PERFORMANCE SPECIFICATION SHEET

MICROPHONE ASSEMBLY, M100/AIC

(Project: 5965-0352)

FIGURE 1. Microphone assembly, M100/AIC

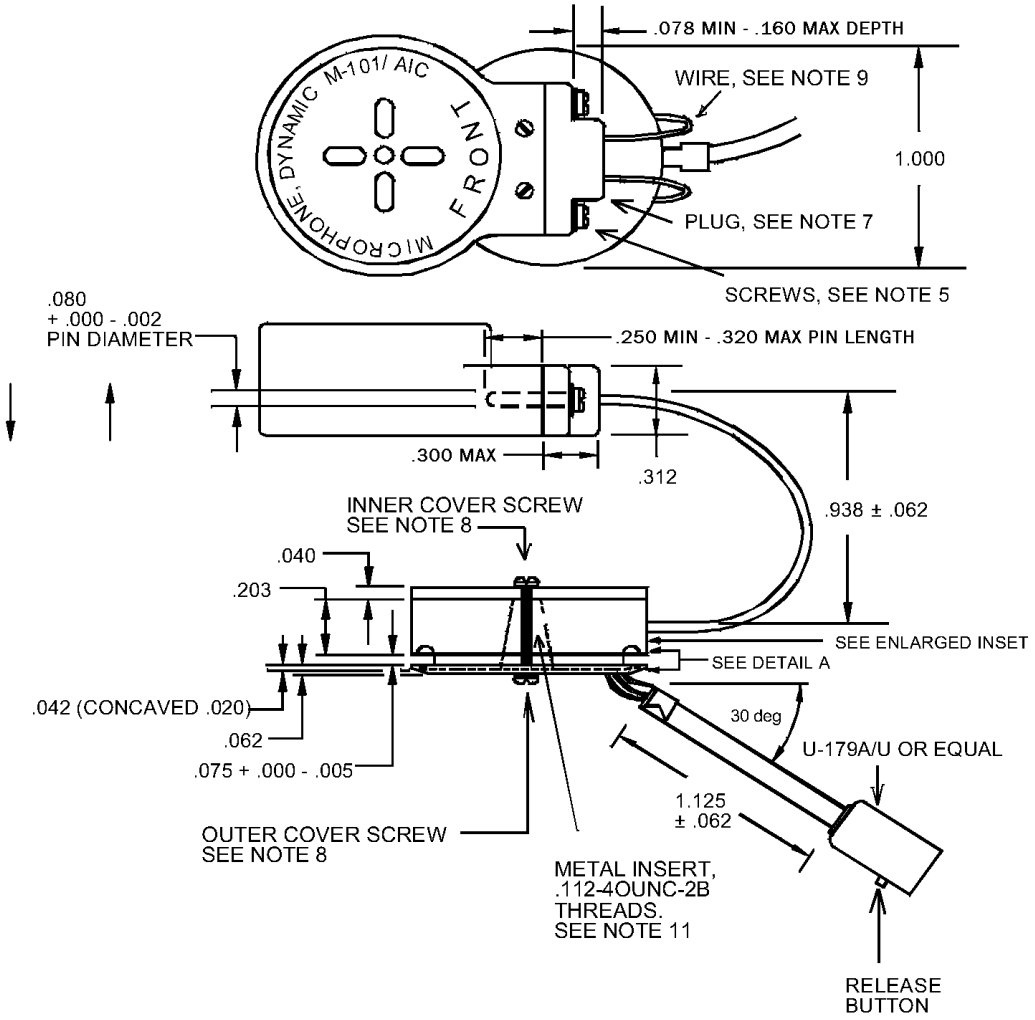
FIGURE 1 (PAGE 1 ONLY): Delete and substitute:

FIGURE 1., NOTE 5, line 1: Delete “AN500D-6” and substitute “AN500D2-6”

NOTE 7: Delete and substitute:

“Plug dimensions shall enable the plug pins to seat firmly in the M-101/AIC microphone element, providing a strong electrical connection, and not becoming detached during normal use. The heads of the screws shall not extend beyond the body of the plug.”
